California Stormwater Quality Association™
Dedicated to the Advancement of Stormwater Quality Management, Science and Regulation

June 11, 2008

Subject: Comments on the March 2008 Draft Construction Stormwater Permit

Figure 1. Local erosion and deposition at a construction site .

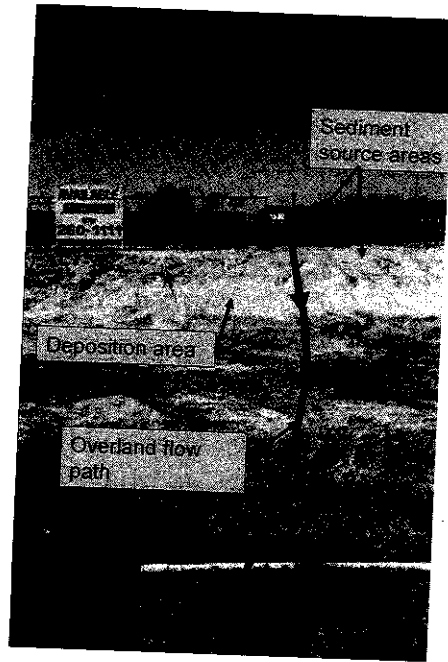
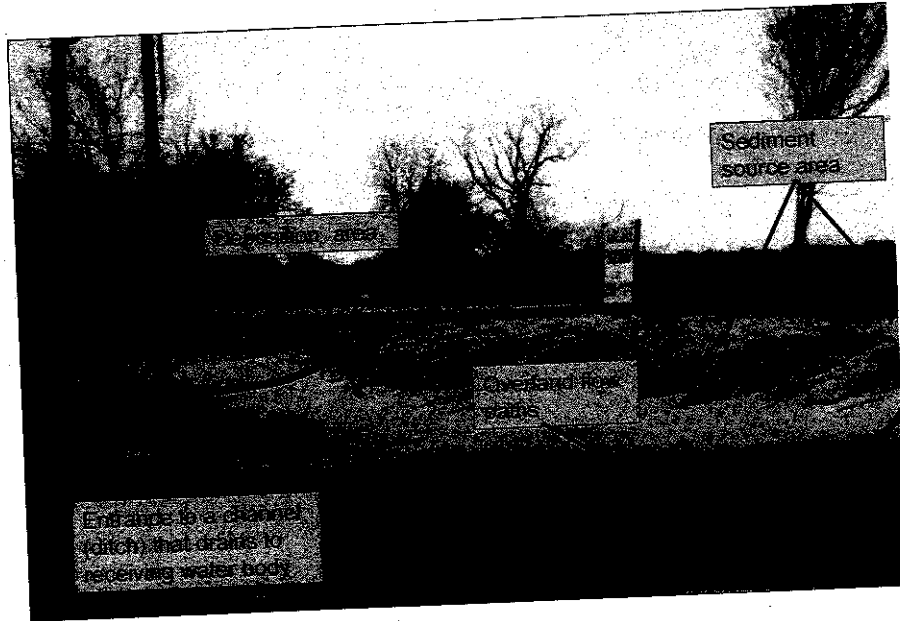
- a. The intent of this worksheet is not clear. Is it a worksheet that estimates the likelihood that whatever sediment, regardless of amount, that is eroded on-site will be transported to a receiving water body? Apparently the worksheet can be used to determine whether erosion control is needed. What is the tool that helps the planner determine the erosion control that will be installed? Is the worksheet essentially giving a sediment delivery ratio that will be used in conjunction with a sediment production computation to estimate sediment delivery in terms of an absolute amount to the water body? Or, is the worksheet estimating sediment delivery by computing sediment delivery amount. The idea of risk is not clear. Why not compute an expected sediment delivery amount and then apply erosion and sediment control to control sediment delivery to an allowable level?

- b. The proximity to receiving water topic needs additional consideration. If the source area is directly connected to the receiving water body, a value of 50 is assigned regardless of the amount of sediment produced. A better approach would be to compute a sediment production value and use the proximity to stream index as a sediment delivery ratio multiplier. Also, increased detail of the intervening area between the source area and the direct connecting path and sediment transport characteristics along the sediment transport path is needed. Consider Figures 1 and 2 below. These photographs are of a construction site after placement of fill and grading. Note that overland flow runoff flows along a relatively long, flat area, then across a short steep area, then on to a flat area that is well covered with grass, and then into a channel that carries storm runoff into a perennial stream about a ¼ mile away. Note the high amount of deposition that is caused by the low steepness that is grass covered between the erosion area and the channel that collects the overland land flow. As much as 80 percent of the sediment that was eroded on this site never left the site because of this deposition. The permit procedure should take into account the likelihood of deposition between the erosional areas and the point that the sediment leaves the site. A multiplier involving perhaps four classes is more appropriate than the additive factor of either 0 or 50.

- c. The question "Will the site be cleared and graded outside of the designated rainy seasons and will Erosivity Index R be less than 5?" is unclear? Must both of these

- conditions be met for a 0 score. If R is less than 5, does the time of clearing and grading make a difference in assigning an index value? Why not ask the question in terms of the R value for the period that the site is susceptible to erosion. If the R for this period is less than 5, then assign a value of 0. Otherwise assign a multiplier value related to the factor of the total annual R during which the site is susceptible to erosion.
